SUBJECT: NuScale Power, LLC Response to NRC Request for Additional Information No. 8990 (eRAI No. 8990) on the NuScale Topical Report, "Loss-of-Coolant Accident Evaluation Model," TR-0516-49422, Revision 0

RAIO-1117-57291

eRAI No.: 8990

NRC Question No.: 15.06.05-7

Figure 3. Thermal resistance network between CNV and UHS

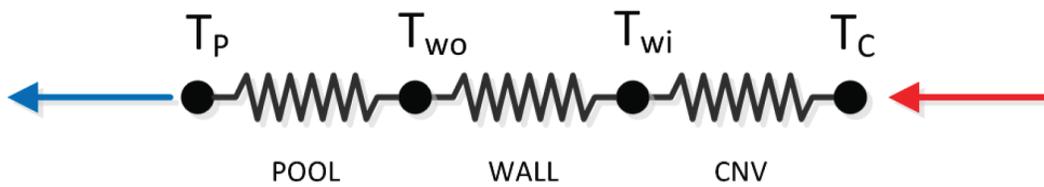
7. The {{^{2(a)(c)}}} did not have enough resolution for NRC staff to reach a conclusion. In particular the NRC staff seeks a better understanding of the period before the peak CNV pressure is reached for a liquid space LOCA (CVCS 100% break). Please demonstrate the relative effects of heat transfer mechanisms on the peak containment pressure {{^{2(a)(c)}}} with better resolution.

The temperature differences corresponding to different heat transfer mechanisms depicted in Figure 3 are plotted in Figure 11 at different CNV elevations. {{
